Access Compliance Report Public Rights-of-Way (Curb Ramps)

Main Street: FALABELLA_DR Cross Street: HANOVERIAN_WAY Location: NW

ADA ID: RPRK211112150633 Ramp Type: Type 4 - Parallel Initial Pass/Fail: Fail Overall Compliance: No Severity Score: 16

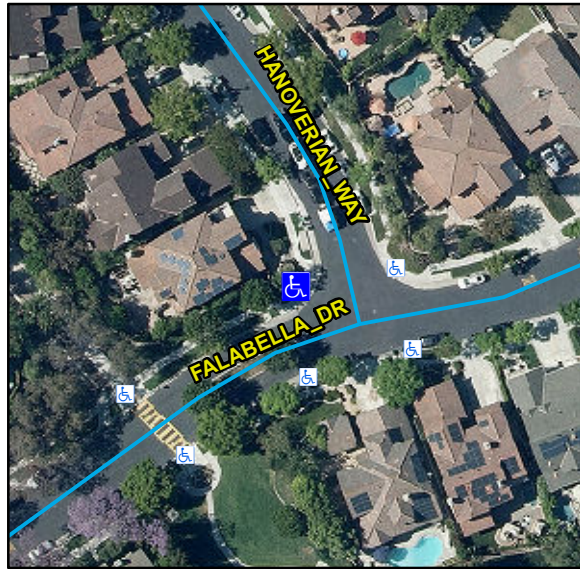
Compliance	Description	Data	Compliance	Description	Data
N/A	Ramp Length LT (in)	129	N/A	Ramp Length RT (in)	128
Yes	Ramp Width LT (in)	54	Yes	Ramp Width RT (in)	54
Yes	Ramp Run Slope LT (%)	2.1	No	Ramp Run Slope RT (%)	9.7
Yes	Ramp Cross Slope LT (%)	1.9	No	Ramp Cross Slope RT (%)	2.6
N/A	Landing Present	N/A	N/A	DWS Provided	N/A
N/A	Landing Length (in)	N/A	N/A	DWS Contrast	N/A
N/A	Landing Width (in)	N/A	N/A	DWS Length (in)	N/A
N/A	Landing Run Slope (%)	N/A	N/A	DWS Full Width	N/A
N/A	Landing Cross Slope (%)	N/A		DWS Offset Type	N/A
N/A	Landing Movement Obstructed?	N/A	N/A	DWS Offset Left (in)	N/A
	Landing Movement Type	N/A	N/A	DWS Offset Right (in)	N/A
N/A	Landing Shared	N/A			
N/A	Clear Space	Yes			
N/A	Clear Space To Crosswalk (in)	N/A			
N/A	Marked Crosswalk 1	No	N/A	Marked Crosswalk 2	No
	Crossing 1 Direction	S		Crossing 2 Direction	E
	Marked Crosswalk 1 Width (in)	N/A		Marked Crosswalk 2 Width (in)	N/A

Remove & Replace Curb Ramp With Two New Directional Ramps or Equivalent.
